Wichita-Sedgwick County Metropolitan Area Planning Department

Re: BZA2009-40: City zoning administrative adjustment to reduce the side setback from 6' to 5.3' for an addition. Generally located west of N Park Place and south of 34th Street N (3429 N Park Pl).

Lot 36 & N1/2 37; Block 9, Jones Park Addition, Sedgwick County, Kansas.

SITE PLAN BZA2009-40

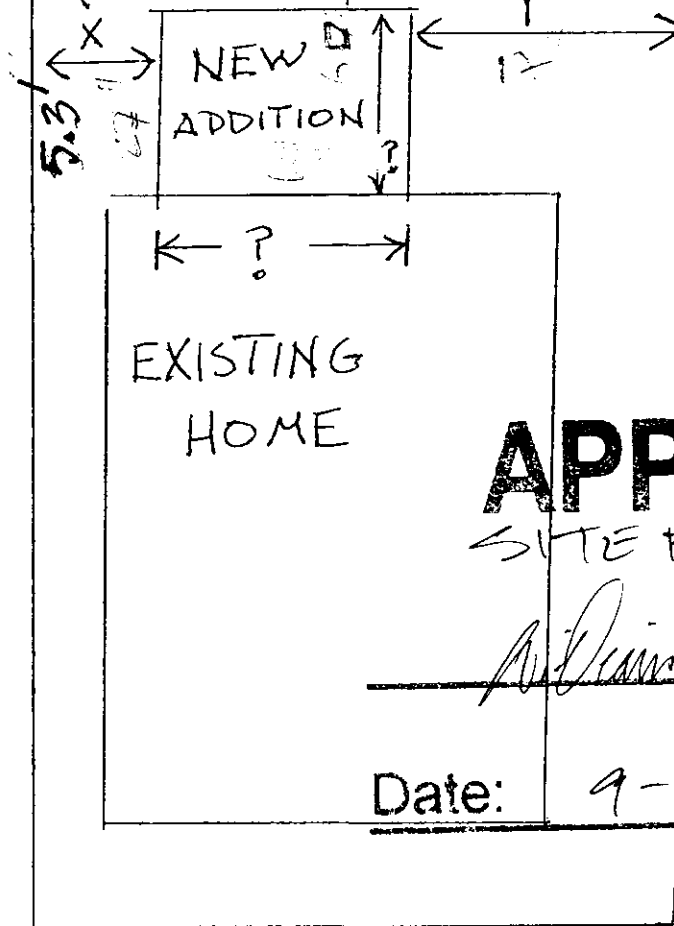
(Already built without permit)

Administrative
Adjustment
for minimum
sideyard setback
of 6' reduced
to accept 5.3'
 $X \approx Y$

MUST BE
AT LEAST
6 FEET
MINIMUM.

MUST BE
AT
LEAST
20 FEET

Our signatures below indicate that a Zoning Adjustment to reduce the side setback for the aforementioned property from 6' to 5.3' for an addition is hereby granted, subject to the following conditions:

- 1) The site shall be developed in general conformance with the approved site plan.
- 2) The site shall be developed in conformance with all applicable codes, including but not limited to building, fire, and health codes.
- 3) The setback reduction shall apply only to the side setback as illustrated on the approved site plan. All other structures or additions on the subject property shall conform to the setbacks permitted by the Unified Zoning Code unless a separate Zoning Adjustment or Variance is granted.
- 4) If the Zoning Administrator finds that there is a violation of any of the conditions of the Zoning Adjustment, the Zoning Administrator, in addition to enforcing the other remedies set forth in the Unified Zoning Code, may, with the concurrence of the Planning Director, declare that the Zoning Adjustment is null and void.
